Fire Marshal Division

Application for Plan Review 08/31/2018 9:54:04 AM

Re: Erwin Denim Days

Application Number - FMFW1808-0008

Misc.-3 MAP 2

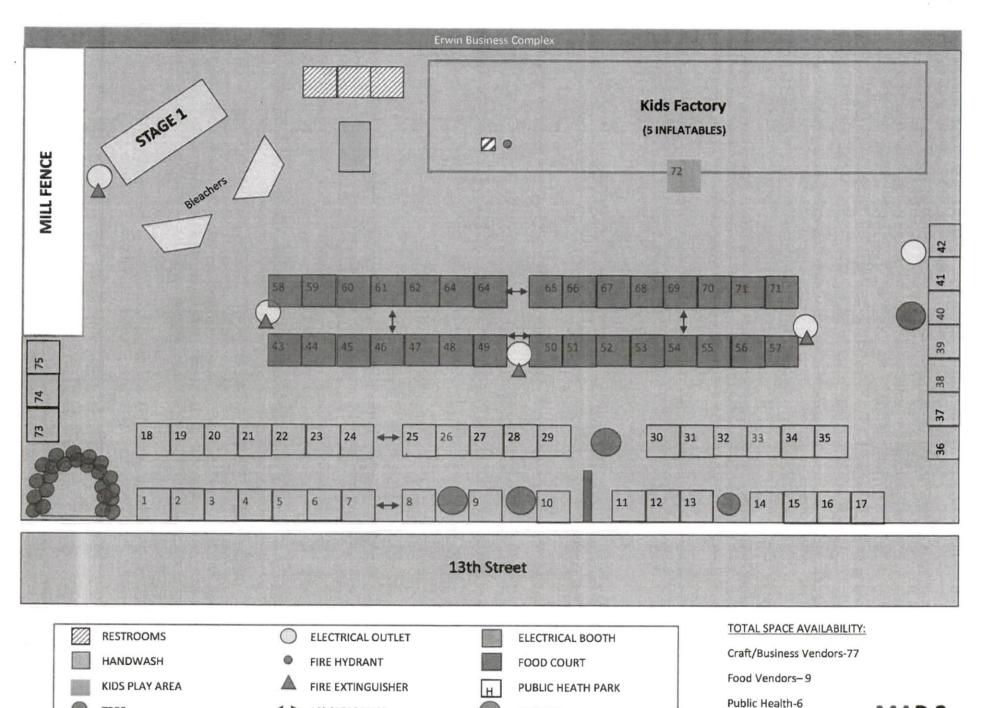
- A permit will be issued for the special assembly that will include the event as a whole.
- A permit may be issued for other tent areas if the individual tent exceeds 700 ft² or the aggregate area of multiple canopies placed side by side without a fire break clearance of 12'

- Portable fire extinguishers shall be provided within a 30-foot (9144 mm) travel distance of commercial-type cooking equipment. Cooking equipment involving vegetable or animal oils and fats shall be protected by a Class K rated portable extinguisher.
- o 2A-10B:C fire extinguisher shall be placed at tents/canopies with a travel distance not to exceed 100' from any fire extinguisher

- Outdoor cooking that produces sparks or grease-laden vapors shall not be performed within 20 feet (6096 mm) from a tent, air-supported, airinflated or tensioned membrane structure, temporary membrane structure
- Cooking is permitted under flame resistant tents meeting NPFA 701 Flame Propagation Standard with a minimum separation of 20' from lot lines, buildings, parked vehicle, other tents and membrane structures.

Tents where cooking is performed shall be separated from other tents, airsupported, air-inflated or tensioned membrane structures, temporary membrane structures or canopies by a minimum of 20 feet (6096 mm).

Generators and other internal combustion power sources shall be separated from tents, air-supported, air-inflated or tensioned membrane structures, temporary membrane structures or canopies by a minimum of 20 feet (6096 mm) and shall be isolated from contact with the public by fencing, enclosure or other approved means.
